POLICY REPORT  
DEVELOPMENT AND BUILDING

TO: Vancouver City Council  
FROM: Director of Planning  
SUBJECT: CD-1 Rezoning - 2665 Renfrew Street

2665 Renfrew Street  
DRAFT CD-1 BY-LAW PROVISIONS

2665 Renfrew Street  
PROPOSED CONDITIONS OF APPROVAL

**STREETSCAPE -  
 ELEVATIONS**

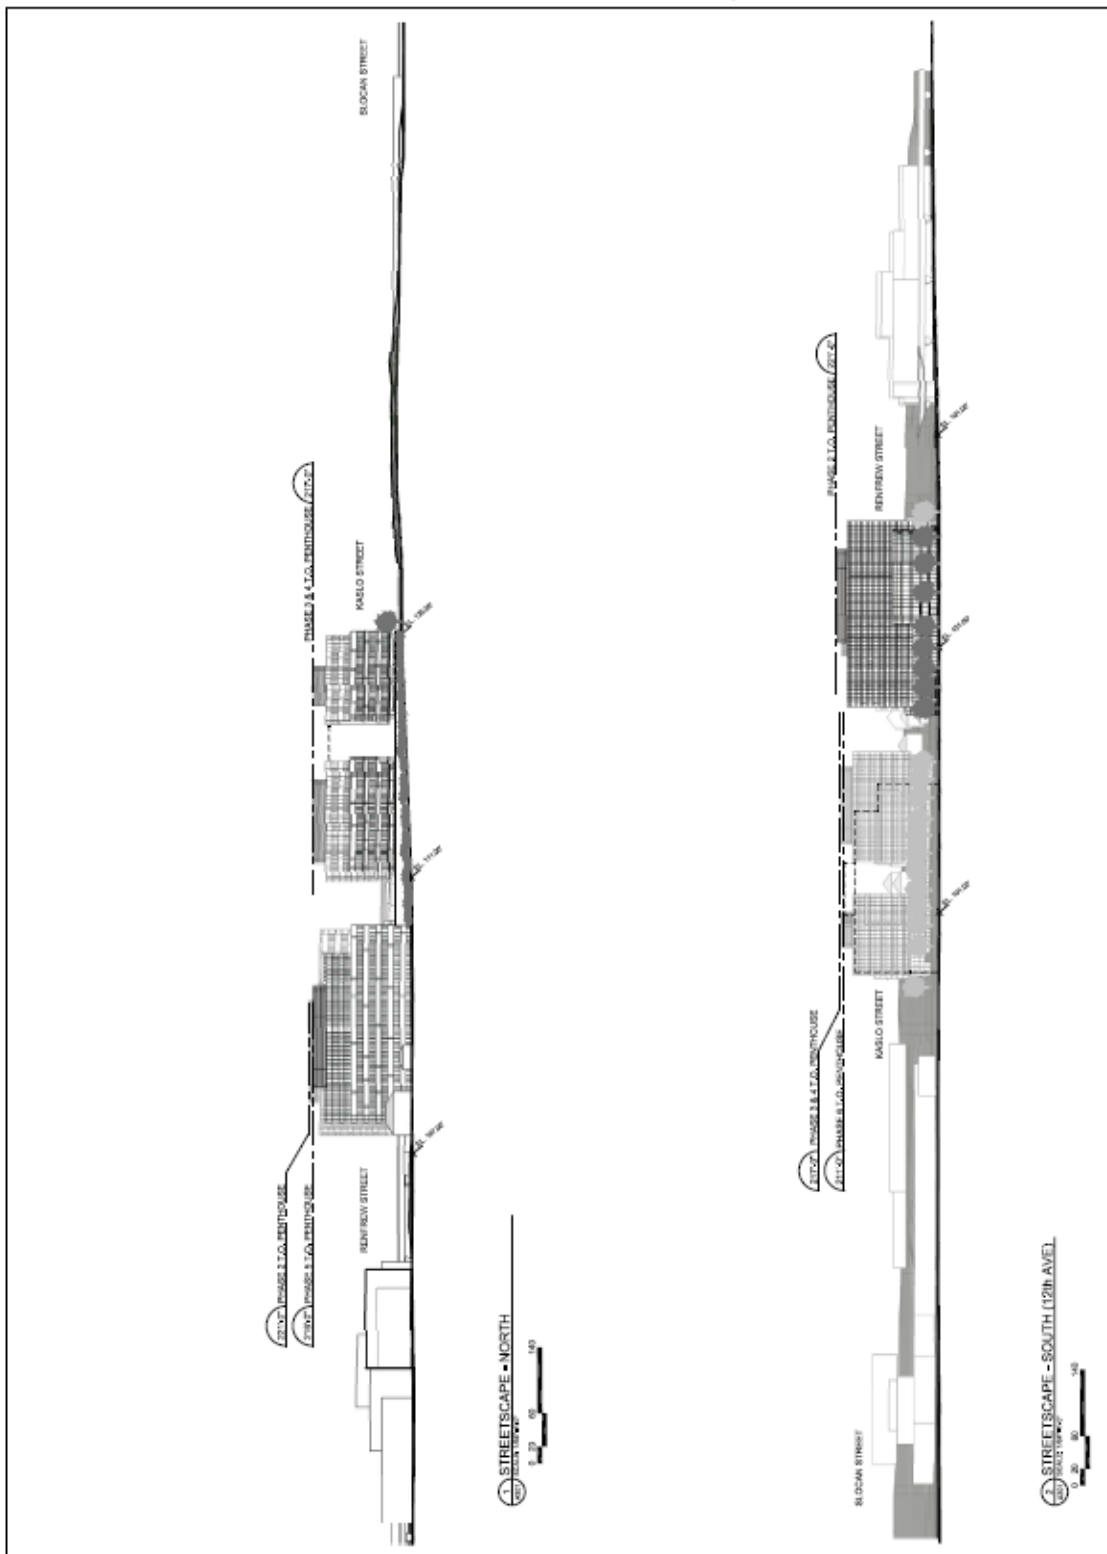
Note to Applicant: As a part of meeting conditions (ii) a) and (ii) e), the solid walls on the north elevation should be replaced with glazing which provides a view to active uses inside. Item (ii) b) should include a protected route from Renfrew Station to the Art Institute. Where feasible, weather protection should provide

- (iv) design development to the north façade of the Phase 2 building to break up the horizontality of the storeys nearest to grade;

Note to Applicant: The intent is to create a more pedestrian scale. This can be accomplished by varying the façade with indentations or projections in plan and in elevation.
